SUBJECT: OPERATION OF ANO-2 DURING CYCLE 2

The Commission has issued the enclosed Amendment No. 24 to Facility Operating License No. NPF-6 for the Arkansas Nuclear One - Unit 2 plant. This amendment consists of changes to the license in accordance with the satisfactory completion of certain conditions to the license. It also consists of changes to the Technical Specifications in accordance with your Cycle 2 Reload Report and request dated February 20 and March 5, 1981 as supplemented by information identified in the Reference Section of the attached Safety Evaluation.

This amendment authorizes Cycle 2 operation subject to the condition in the license which temporarily restricts operation of the facility to seventy percent of the licensed full power level of 2815 Mwt pending completion of the staff's review of the core protection calculator system, and with the following changes.

FIGURE 3.1-2
CEA Insertion Limits vs THERMAL POWER

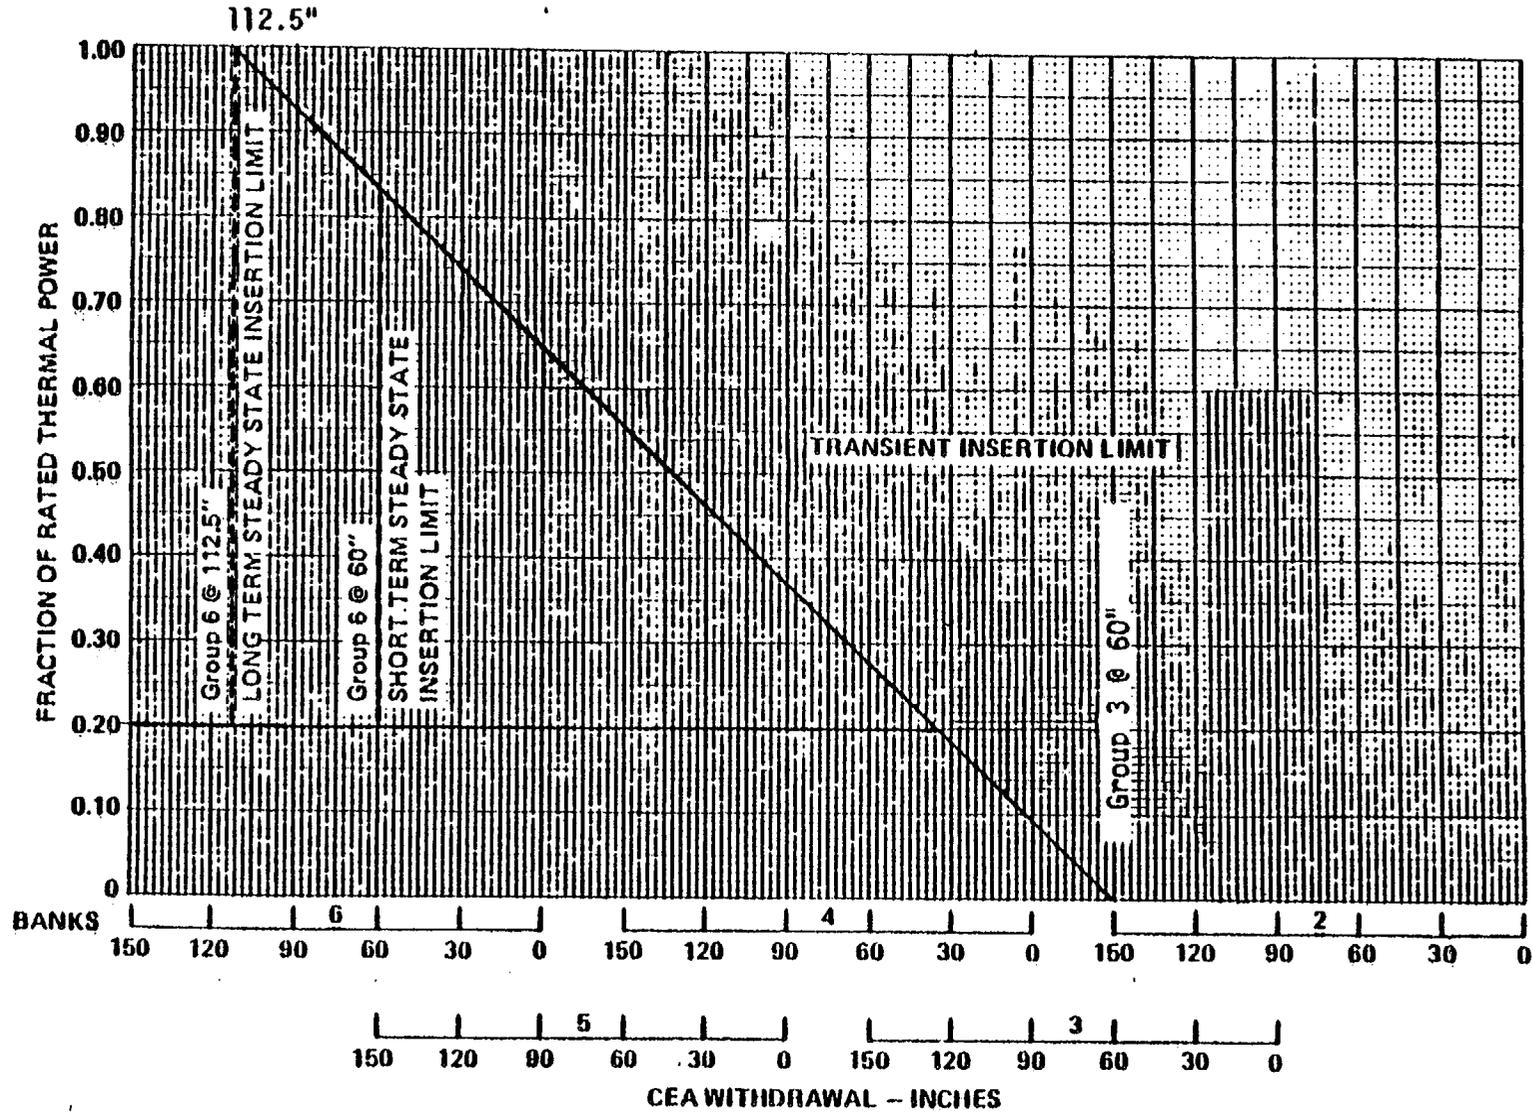
TS Figure 3.1-2 has been changed to reflect the provision of adequate shutdown margin for MODES 1 and 2. The acceptability of the shutdown margin is discussed in Section 2.2.1 of this report. The affected page is 3/4 1-27.

FIGURE 3.2-4
DNBR MARGIN OPERATING LIMIT BASED ON CORE PROTECTION CALCULATORS
(COLSS OUT OF SERVICE)

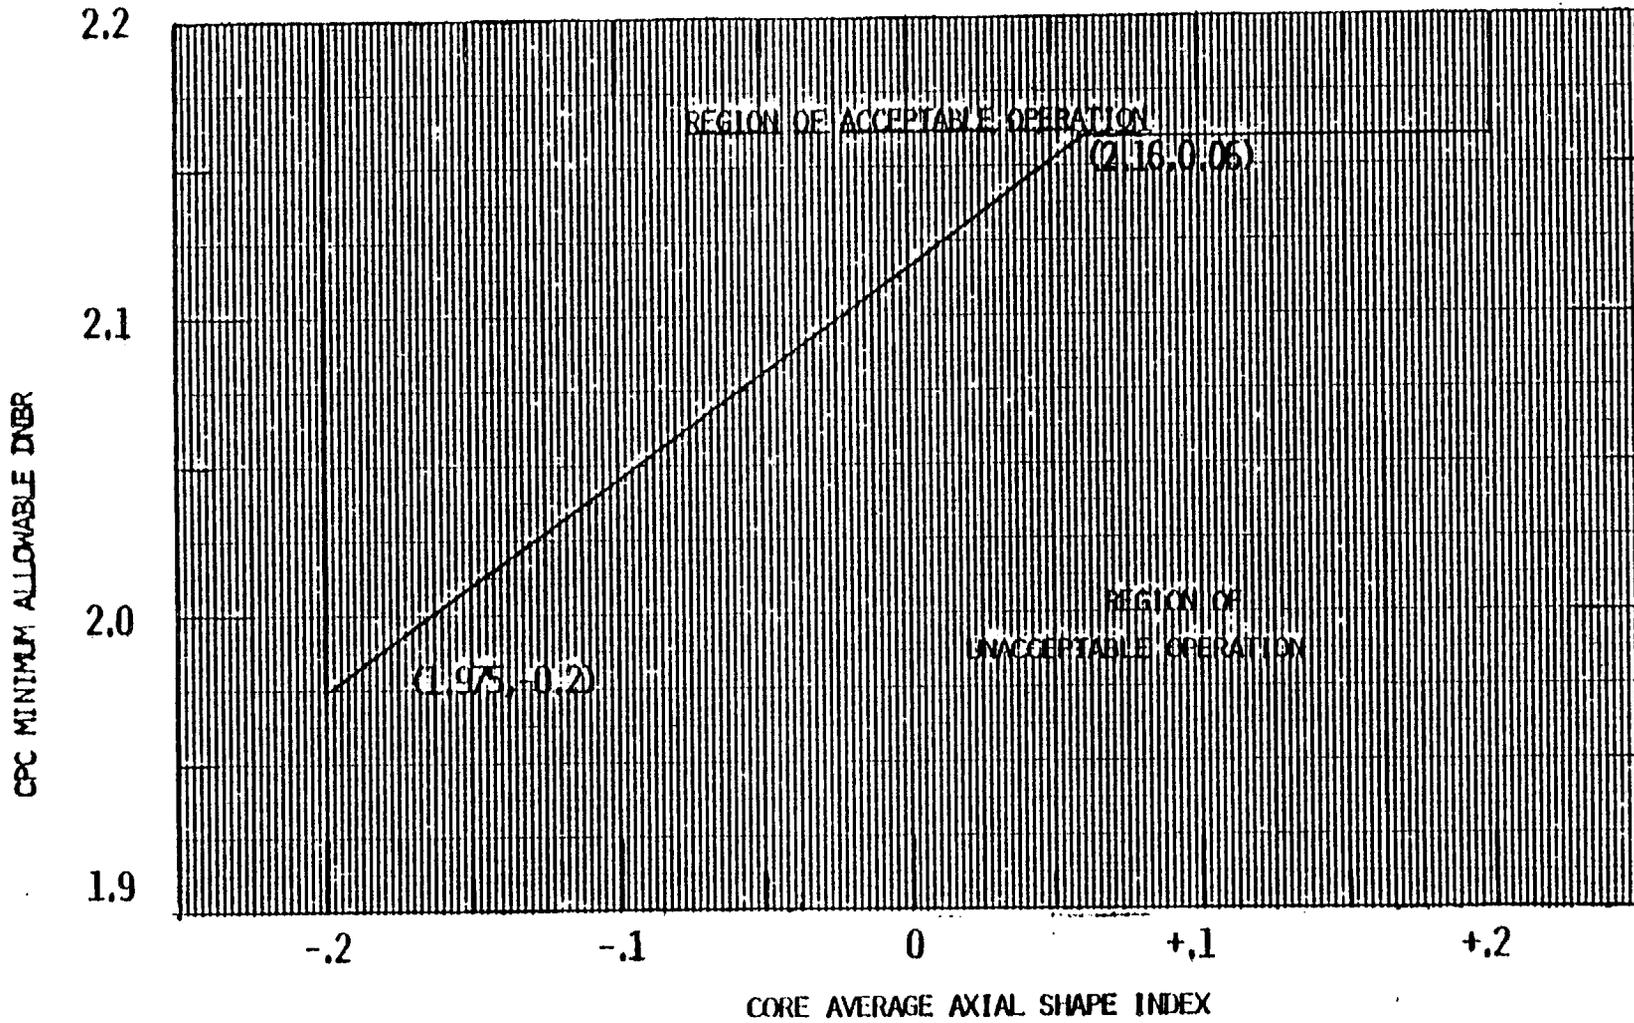
The licensee proposes to change Figure 3.2-4 due to Cycle 2 reanalysis of COLSS out-of-service DNBR margin requirements. These limits are reflected in the determination of the initial conditions for Cycle 2 anticipated operational occurrences which we have evaluated and found acceptable in Section 2.0 of this report. Therefore the proposed change is acceptable. The affected pages are: 3/4 2-7, 3/4 2-9, 3/4 2-10 and B 3/4 2-1.

Figure 3.5-1 Containment Internal Pressure vs. Containment Average Air Temperature

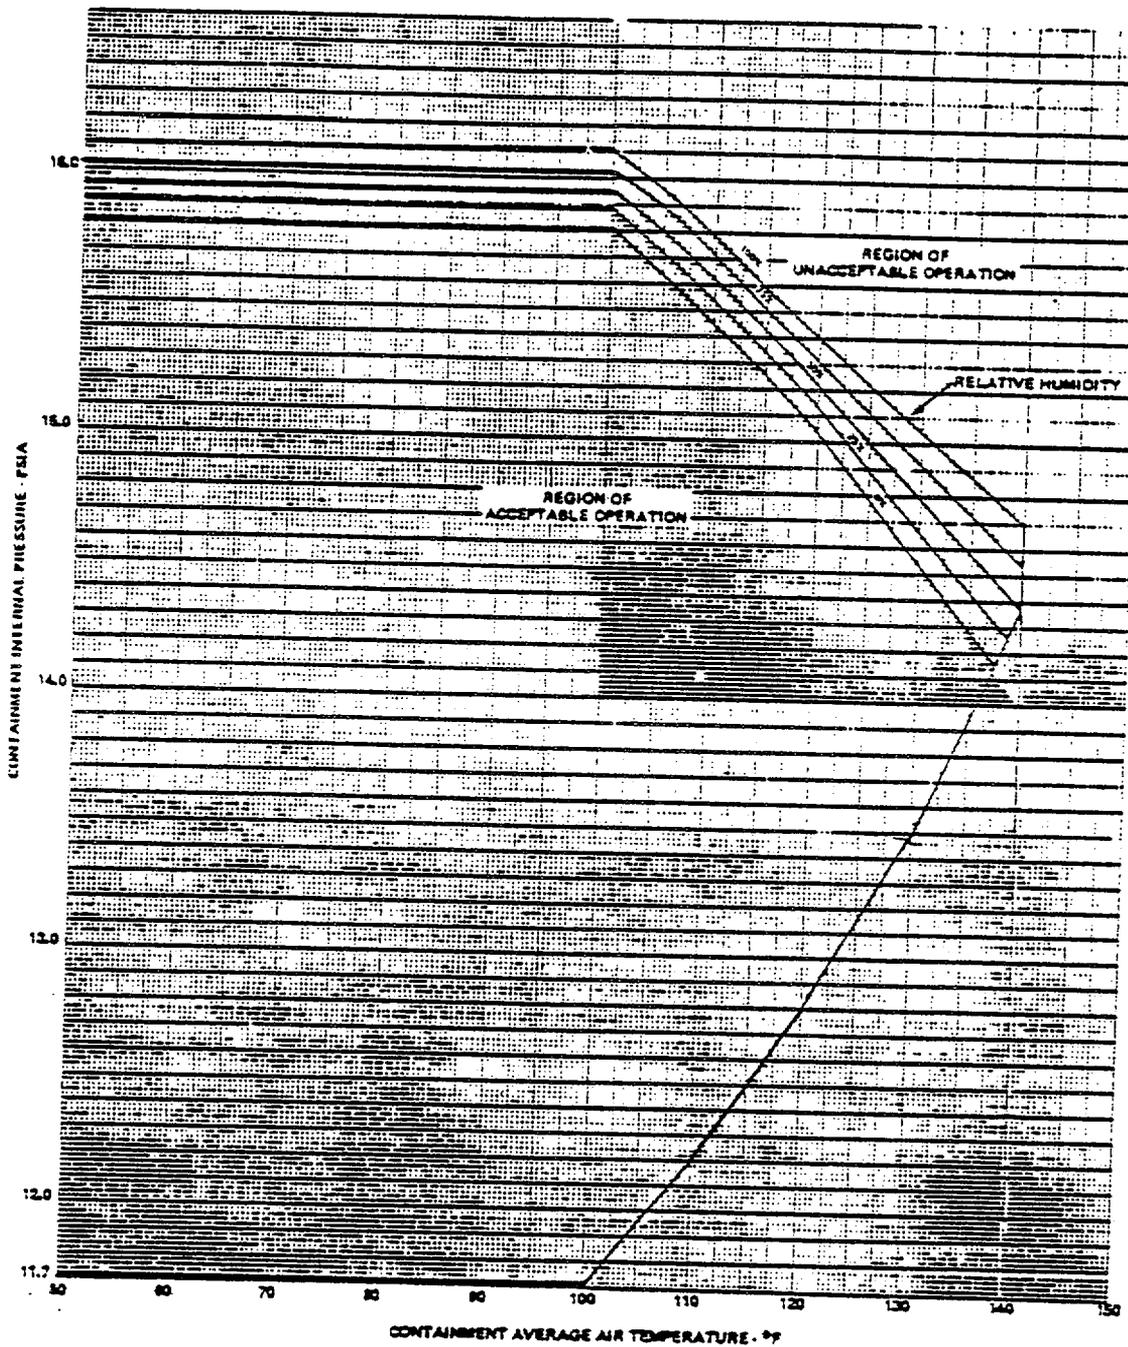
By letter dated November 19, 1979 proposed additional limits on the acceptable combinations of containment pressure and temperature to be included in TS Figure 3.6-1. The acceptability of this change is addressed in Section 2.7.1 of this change is addressed in Section 2.7.1 of this report. The affected page is 3/4 6-7.
